IDAP REPORT

Property:	5 Torrington Road STRATHFIELD LOT: 19 DP: 582 DA2021.77
Proposal:	Demolition of existing structures and construction of a new two (2) storey dwelling house with basement level, in-ground swimming pool and associated landscaping works.
Applicant:	P Kokuleraaj
Owner:	Mr S. Paramsothy
Date of lodgement:	26 April 2021
Notification period:	29 April 2021 to May 13 2021
Submissions received:	NIL
Assessment officer:	G I Choice
Estimated cost of works:	\$1,381,429.00
Zoning:	R2-Low Density Residential - SLEP 2012
Heritage:	No
Flood affected:	Yes
Is a Clause 4.6 Variation Proposed:	No
RECOMMENDATION OF OFFICER:	APPROVAL

Figure 2: Proposed front and east elevations

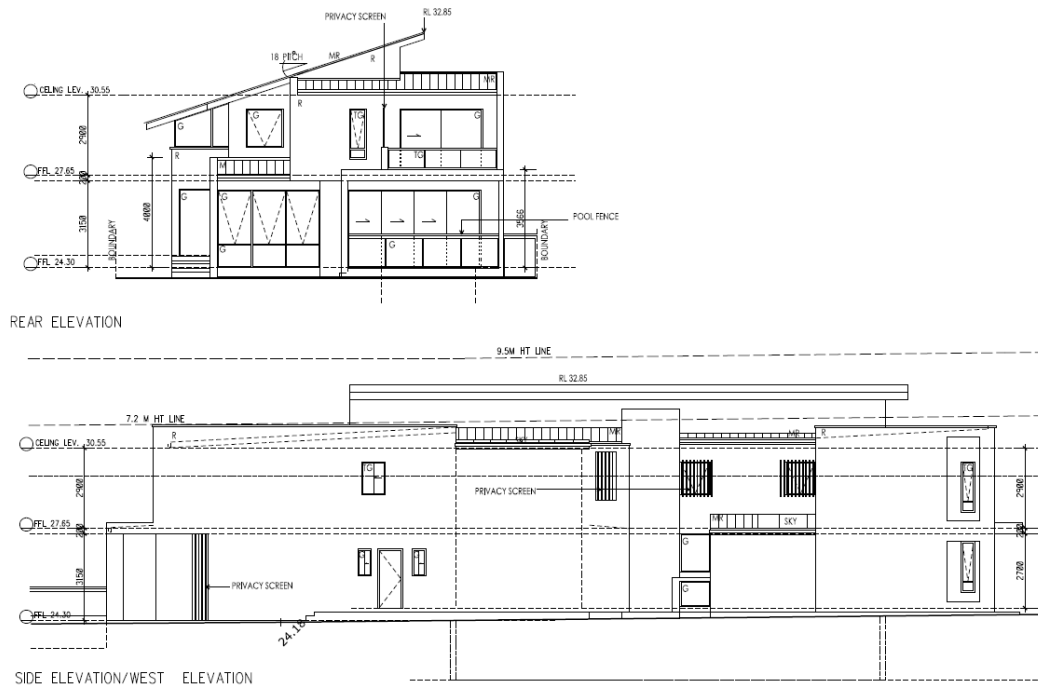
- The proposed basement extends beyond the ground floor dwelling footprint.
- The proposal includes double height vertical slats to a section of the front façade.

The Applicant proposed two (2) possible design options to retain the front façade privacy screening (item ii) while reducing the visual bulk. Council accepted one of the options.
